Memo

Subject: Joint Response to Minute 29

1. This memorandum is provided as part of Matakanui Gold Limited's (**MGL** or **Applicant**) response to the Expert Panel's Request for Information on the Bendigo-Ophir Gold Project (**BOGP**) contained in Minute 29 and should be read alongside the:

Figure 2 Location of proposed Lower Shepherds Creek Wetland.

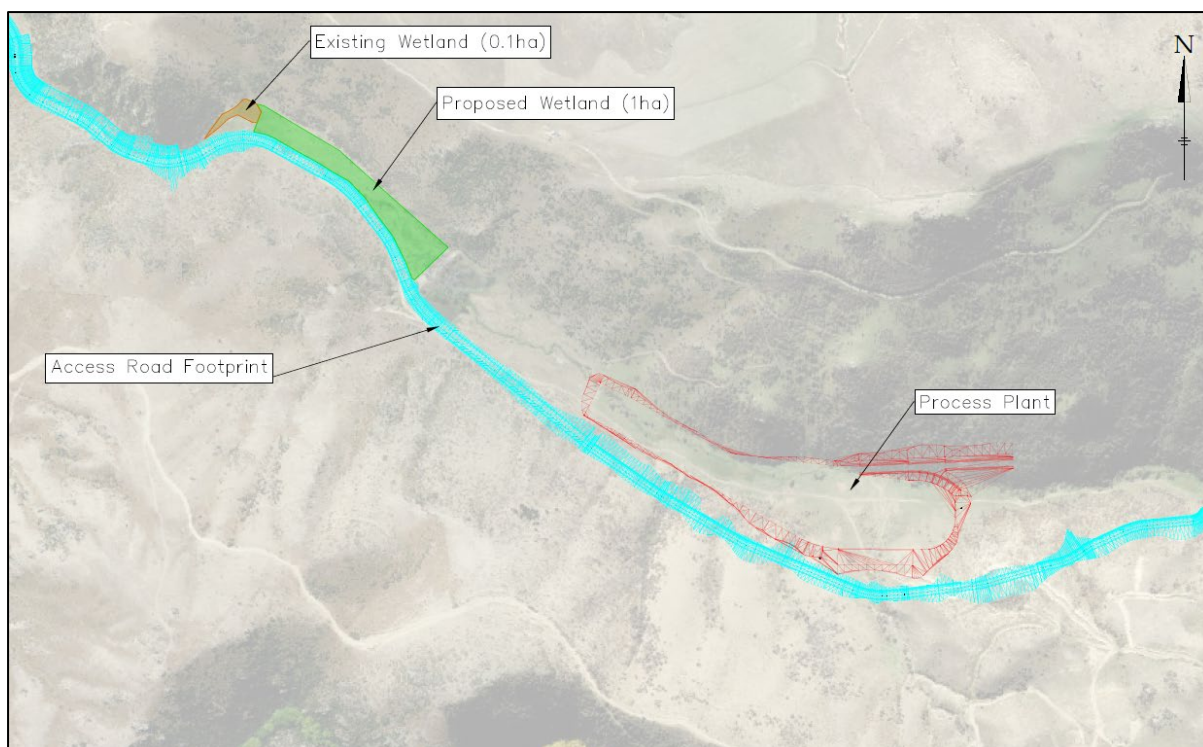
The Lower Shepherds Creek Wetland is proposed to be located within the Shepherds Creek valley bottom, as shown in (Figure 2), with an area of 1 Hecate (ha). This location is approximately 250 m upstream of the water monitoring site SC01, which has a catchment area of approximately 1,200 ha. The wetland will be constructed at the start of mining. It is noteworthy that wetland already exist near this location.

The upstream and downstream flows into and out of the existing wetland at the proposed site should be monitored to allow development of a site water balance. In addition, several shallow piezometers should be strategically placed within the wetland or near its boundaries where is suspected that sub-surface groundwater is contributing to site. Data from the piezometers can also be used to describe the annual fluctuation of subsurface water in response to surface water influx and precipitation. Analysis of data from the existing site will be used to inform the water demand of the proposed upstream extension of the wetland.

Figure 8: Modelled TSF wetland pond area (ha) from January 2025 to December 2124 (0.5 m weir, 2 m flood spillway).

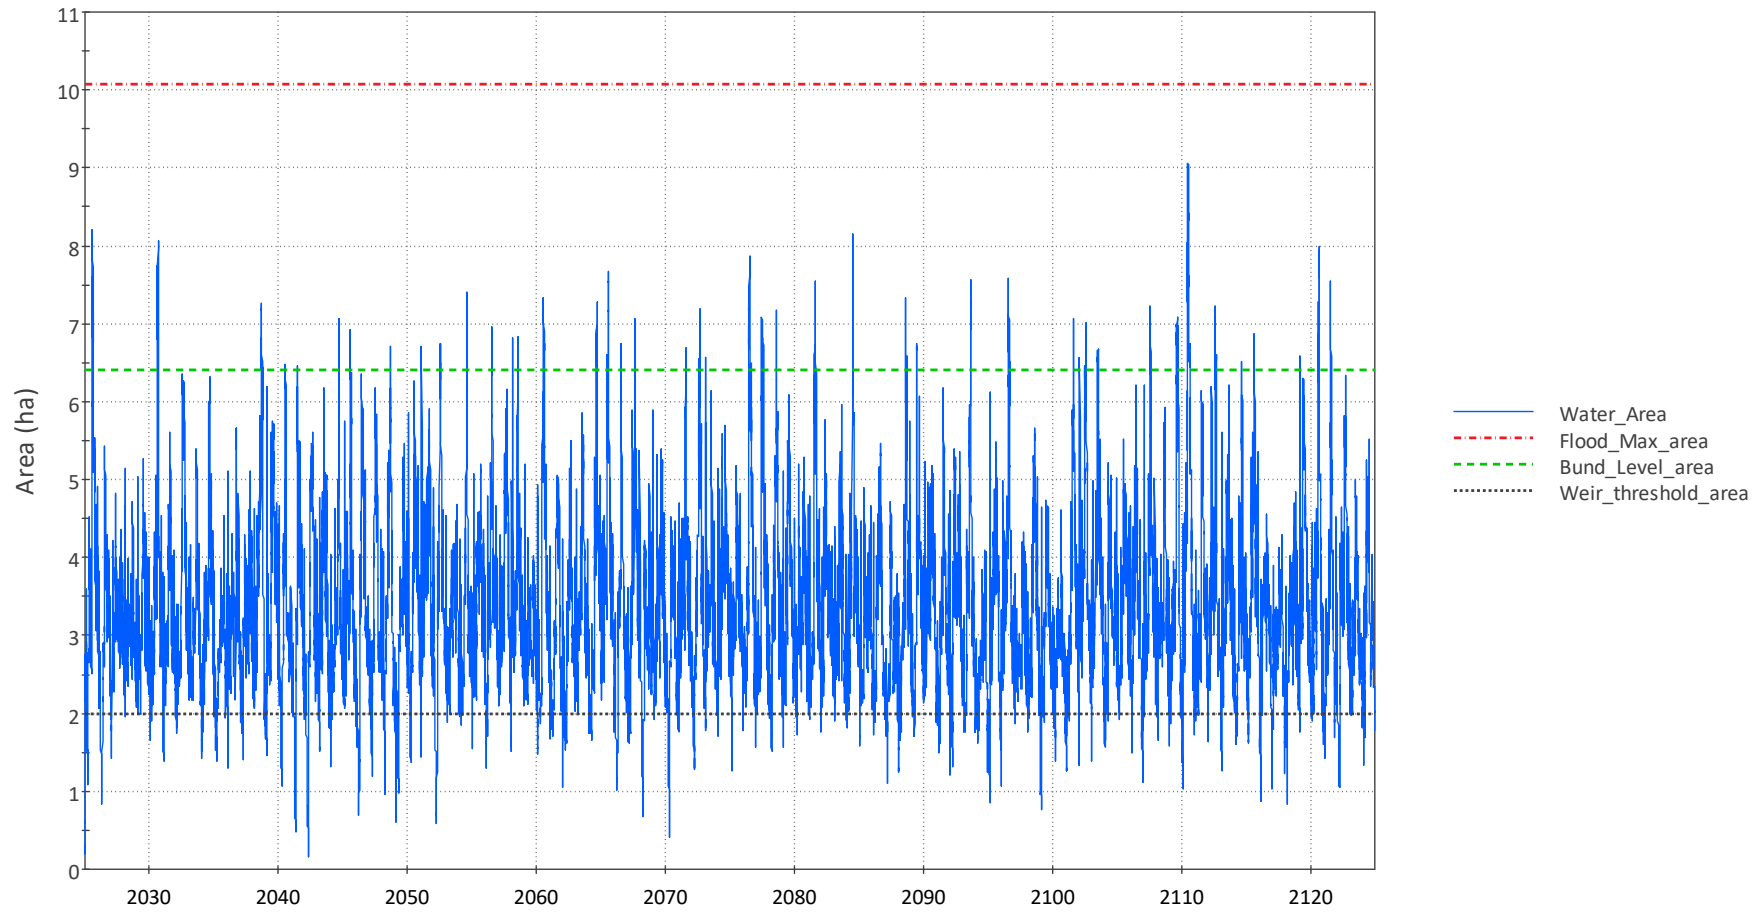
Figure 6 illustrates modelled pond area for the same period and where the equivalent permanent pond threshold area is 2 ha. For the same two dry periods, the pond area decreases to 0.8 ha at its most extreme (excluding the 6-day start-up period). Over an extended period of five years (Figure 7) there is only one more dry period in which the water level falls below 1 ha for 9 days. Over a 100 year period (Figure 8) there is a total of 193 days below 1 ha.

Figure 9: Modelled TSF wetland pond area (ha) from January 2025 to December 2026 (no weir, 2 m flood spillway).

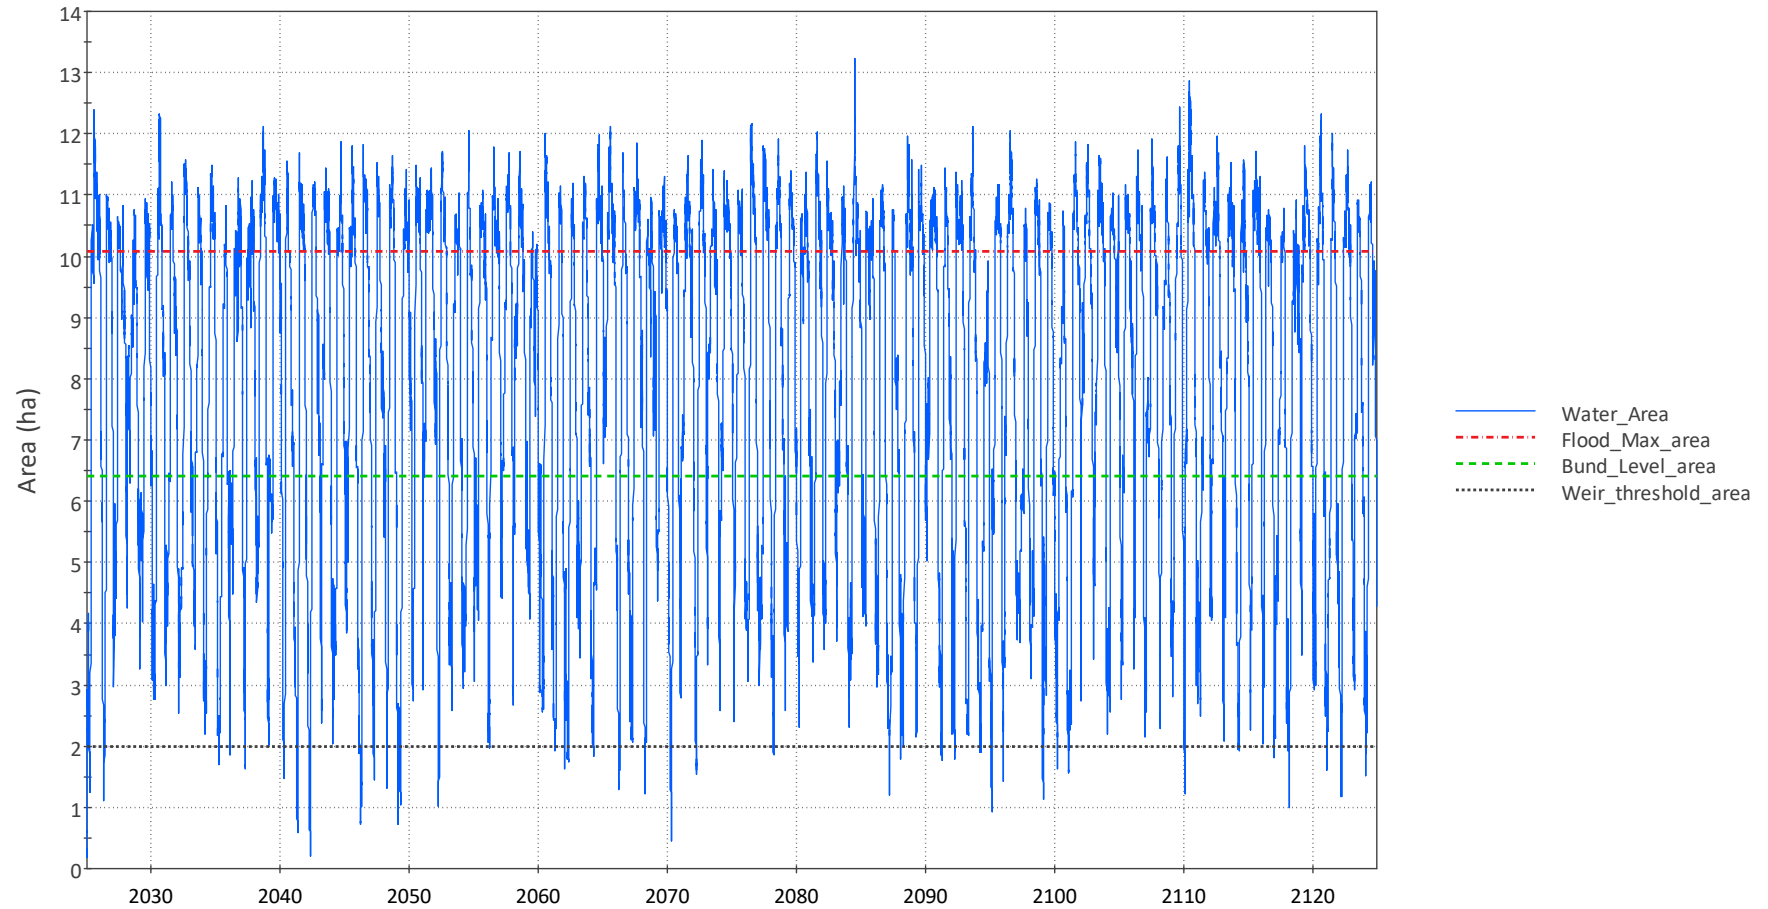
To reduce the amount of drainage from the pond in dry periods the wetland was modelled without the lower weir (Figure 9). This resulted in a higher mean water area (7.9 ha compared to 3.3 ha with the weir), and just 100 days in which the pond fell below 1 ha.

Figure 1

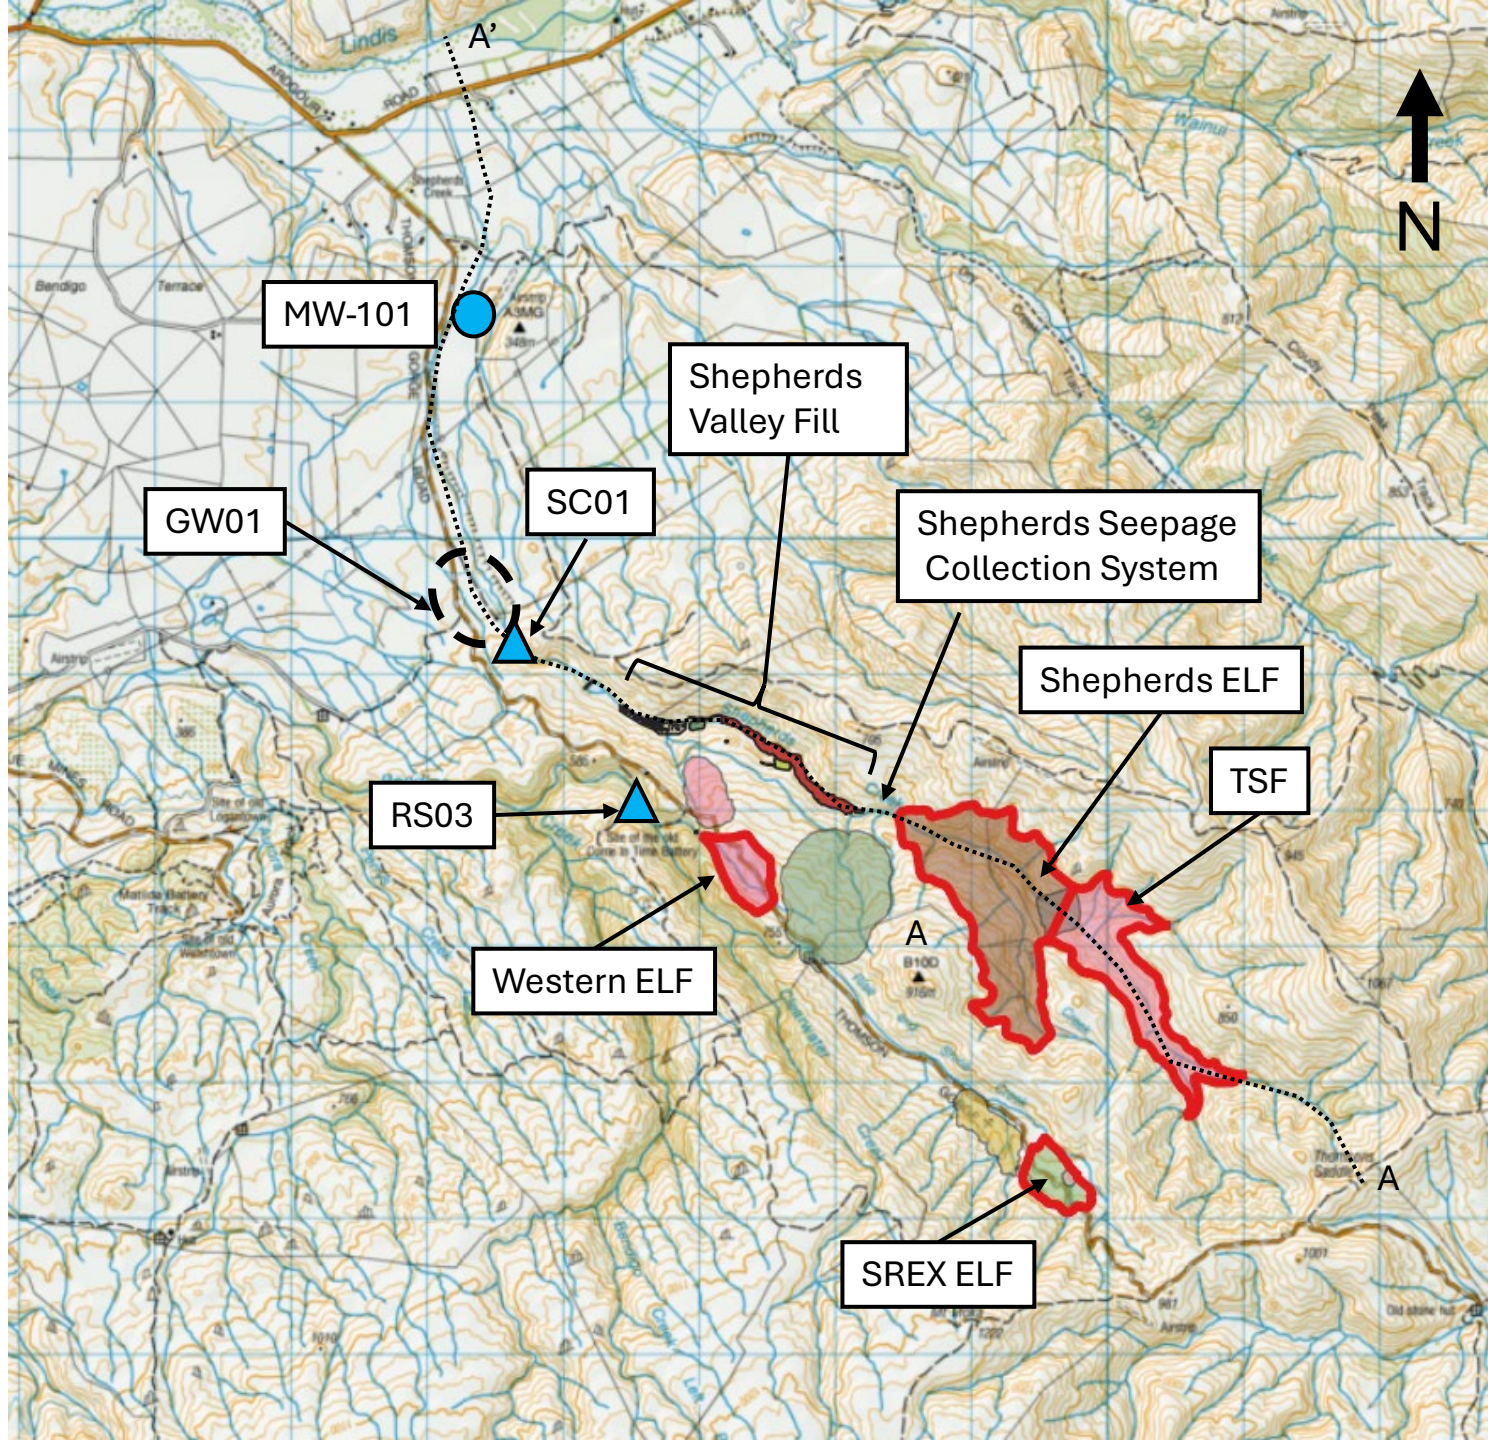
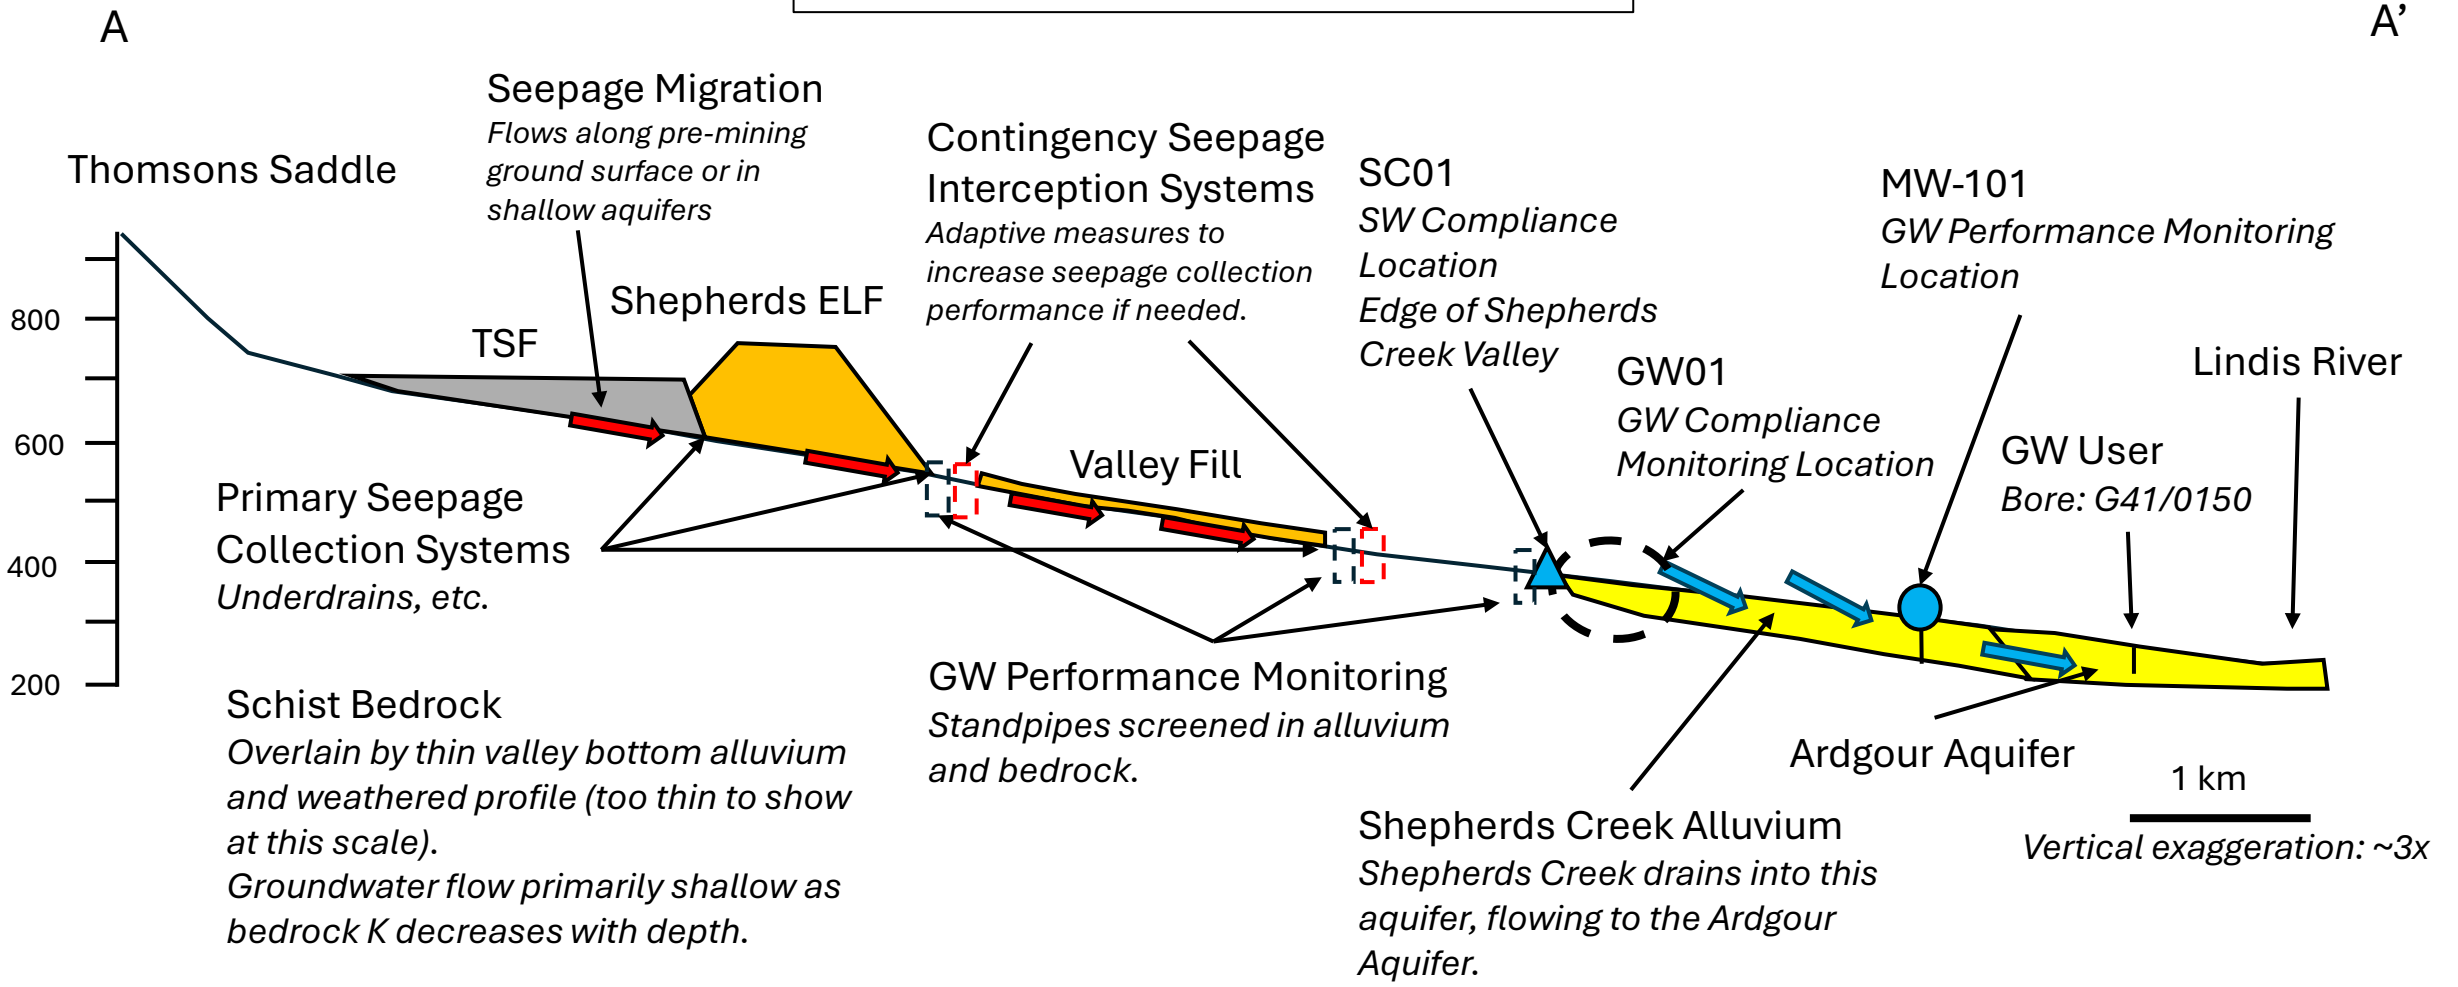
77. Figures 1 and 2 of Attachment B show the conceptual arrangement of how MWSFs, seepage collection, performance and compliance groundwater monitoring are planned to be situated along the Shepherds Creek valley and Ardgour Terrace towards the Lindis River.
